# UNITED STATES PATENT AND TRADEMARK OFFICE

APPLICATION NO.	FILING DATE	FIRST NAMED INVENTOR	ATTORNEY DOCKET NO.	CONFIRMATION NO.
10/791,088	03/02/2004	Michael Diesler	2002P18158US	2926

**Office Action Summary**

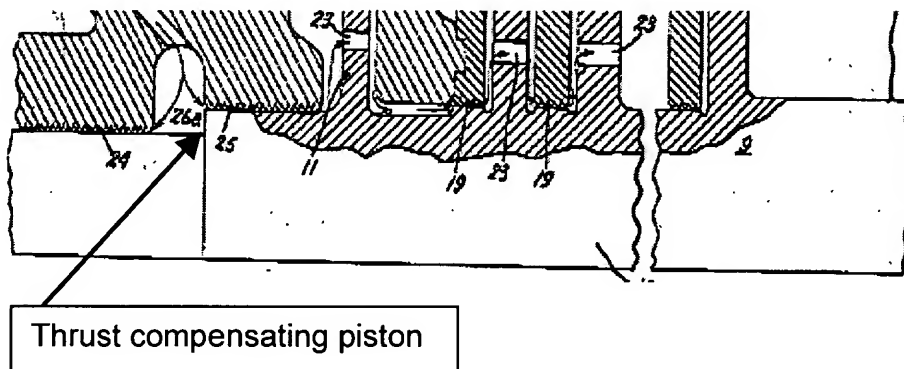
Applicant next argues that Warren does not teach a thrust compensating piston. As seen in the annotated Figure below, the thrust-compensating piston is defined by the rotor shaft change in thickness.

The end of the rotor 10 adjacent the inflow region 26a defines a thrust-compensating piston.
